Pre-Application Review

39-lot Preliminary Plat
18614 and 18718 134th St SE
Tax Parcels: 28063600200600 & 26063600101300

Meeting Date: December 3, 2024

Figure 22.16.040(E)(3)(b). Yard Setback Determination from Utility Easement

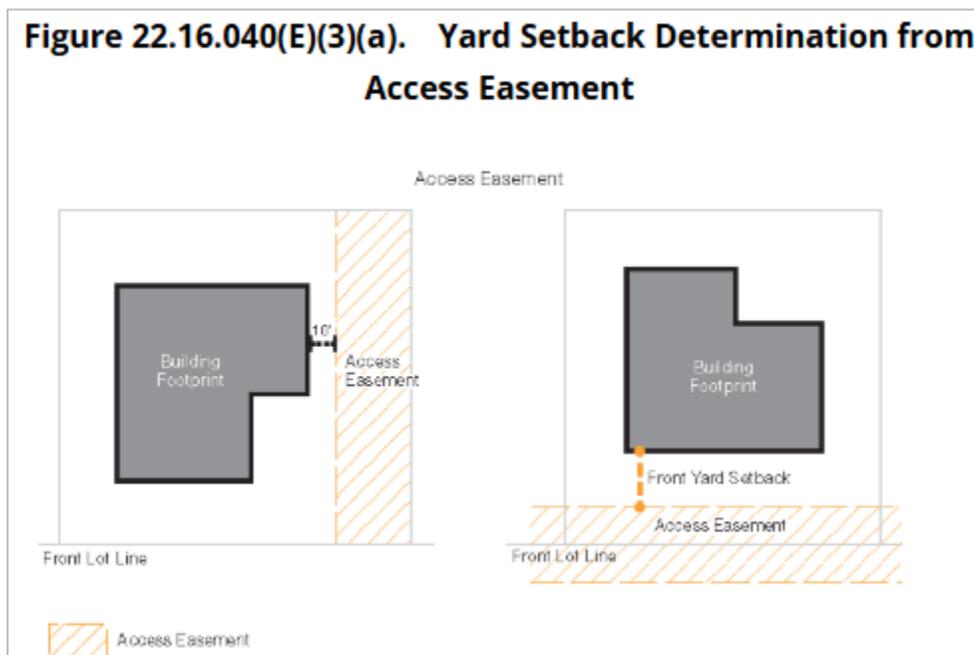
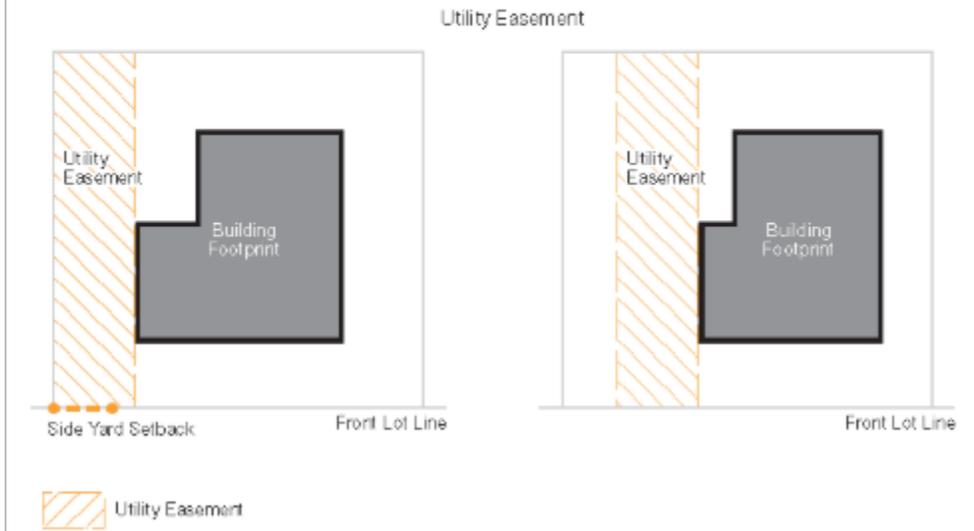
4. Critical areas study may be required to confirm that no critical areas exist on site; steep slopes appear to exist along the south property lines.
5. Sixty-foot (60') Ingress, Egress, and Utility Easement within and along the east side of proposed Lots 17-25. Per the Residential Bulk Standards in MMC Section 22.16.040, Subsection E(3)(a) and (b), the lots can include the easement(s). The applicant is required to submit a letter or other written communication from Williams Northwest Pipeline (Northwest) approving requested encroachment into said easement(s).
